SG/GK
14274
20 December 2016

**S96(1A) - MODIFICATION APPLICATION - SSD 14_6673 – MOD 2
BLOCK 4N, CENTRAL PARK**

Figure 1 – Existing and proposed public domain plan (Block 4N SSD)
Source: Foster + Partners

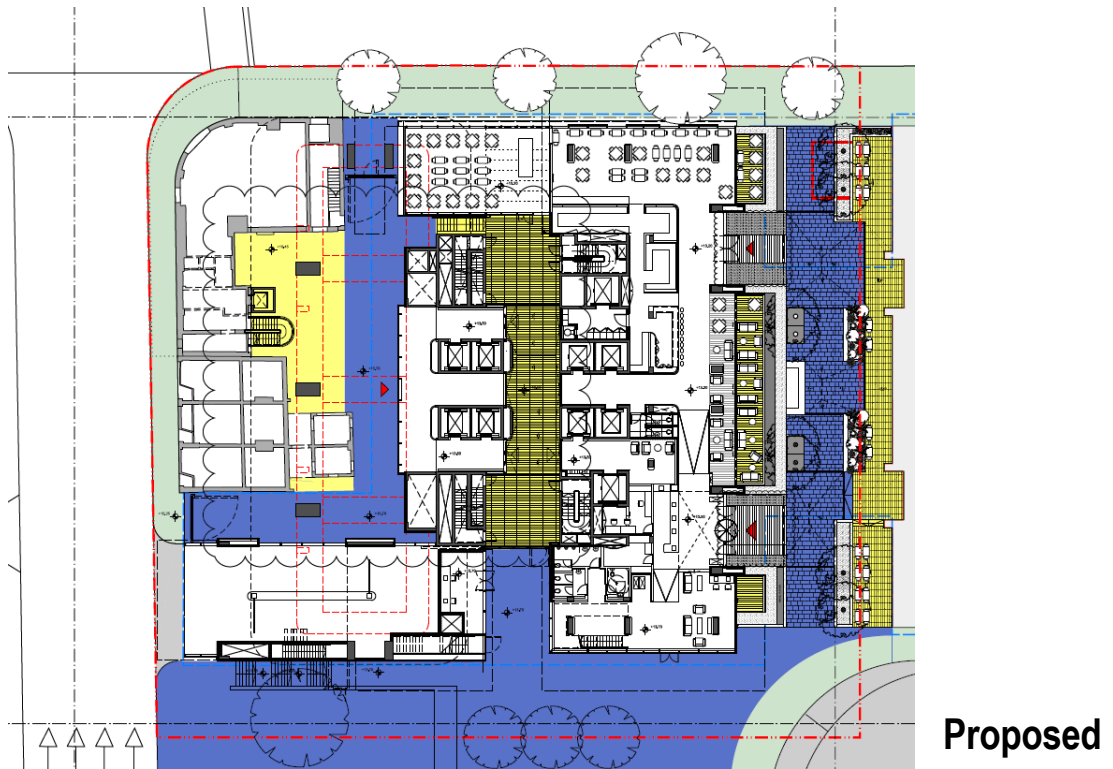
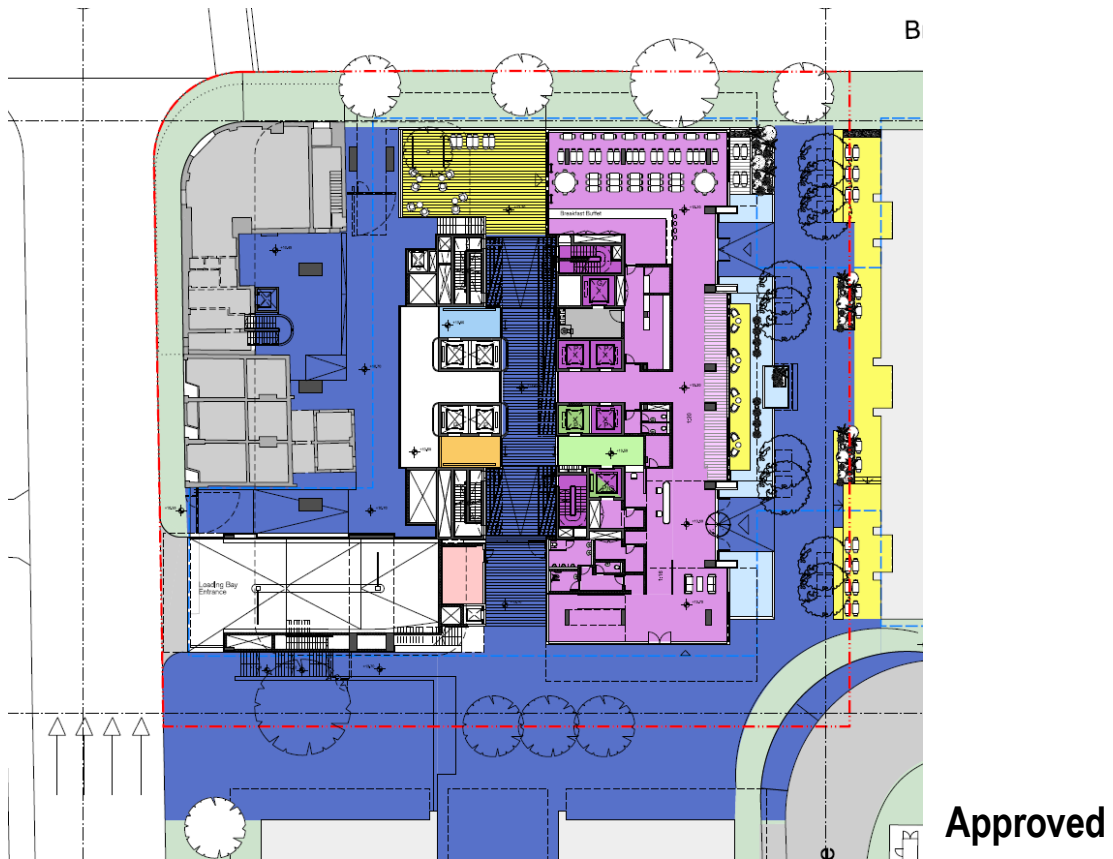
The Heritage Courtyard (as shown in **Figure 1**) has always been intended to be comprised of two distinct uses; as a primary space at the rear hotel & terraces for retail, and as the main thoroughfare and circulation route to the office lobby. This delineation of use was referenced in the Foster + Partners Architectural Design Report along with the Urbis Heritage Interpretation Plan for the Block 4N SSD. However, the clarification of this courtyard use was not accurately reflected on the public domain plan (drawing PA-A4-1600 – Public Domain Plan).

As shown in the figure produced by Foster + Partners (**Attachment B**), the modification seeks to clarify the use of the Heritage Courtyard, showing the primary space at the rear of the Australian Hotel and terraces as zone of exclusive use by tenants whilst maintaining the publicly accessible thoroughway for the circulation route, providing access to the office lobby.

Architectural (or Design) Drawings prepared by Foster + Partners			
Drawing No.	Rev	Name of Plan	Date
(Delete existing plans and replace with plans provided at Attachment A and D) - Specifically Drawing PA-A4-1600- Public Domain Plan Drawing PA-A1-1752 – Basement Level 2
